CSB Public Meeting

DuPont La Porte Investigation Update

July 22, 2015

Process Hazard Analysis

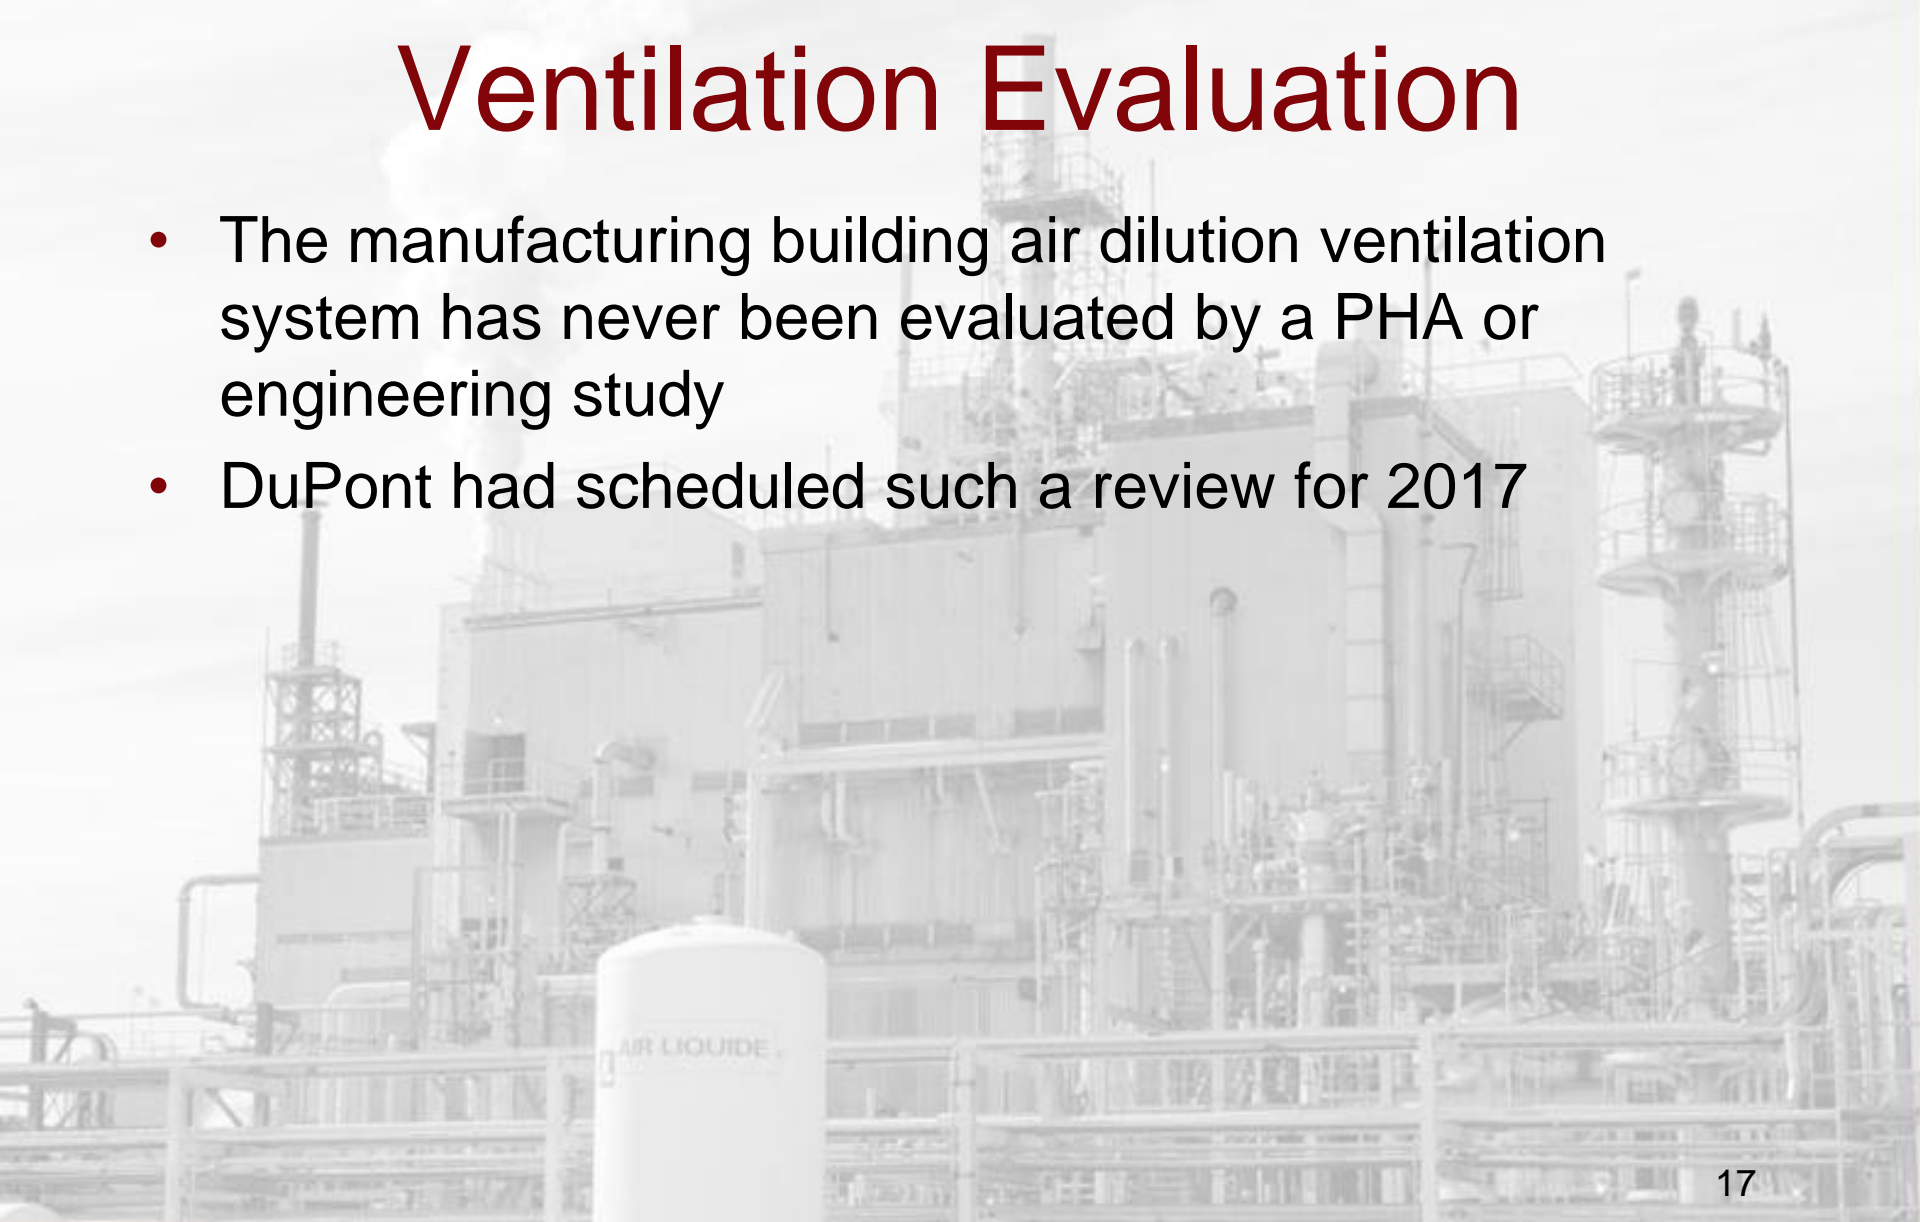
- Process hazard analyses (PHAs) and relief system design scenarios do not effectively consider hazards from nonroutine operations, such as aligning the liquid methyl mercaptan piping to the vapor waste gas vent header
- Along the liquid methyl mercaptan feed line there were three locations where it was connected by valves to a waste gas vent header
- At the time of the incident one of these valves was fully open and a second valve was slightly open
